Access Compliance Report Public Rights-of-Way (Curb Ramps)

Main Street: LASSEN_DR Cross Street: ESPLANADE_AVE Location: SW

ADA ID: RPAT211026135644 Ramp Type: Type 6 - Directional 1 Initial Pass/Fail: Pass Overall Compliance: No Severity Score: 6

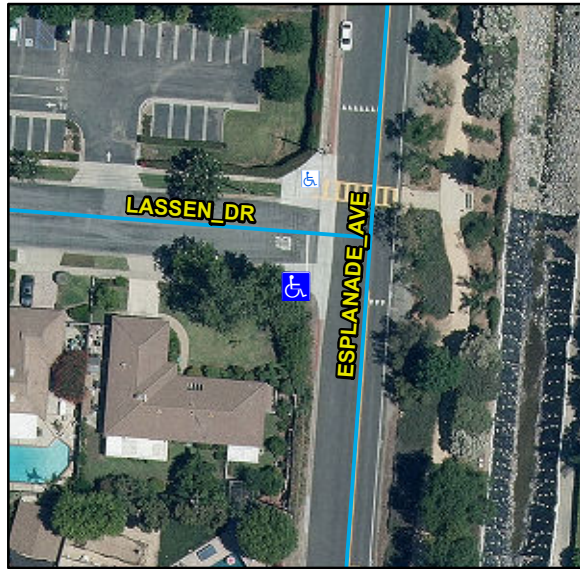
R304.2.2, R304.2.1, R304.2.2-Perp, R304.3.2-Para, R304.5.3, STD 1115

Remove & Replace Entire Ramp. Remove & Replace Gutter.
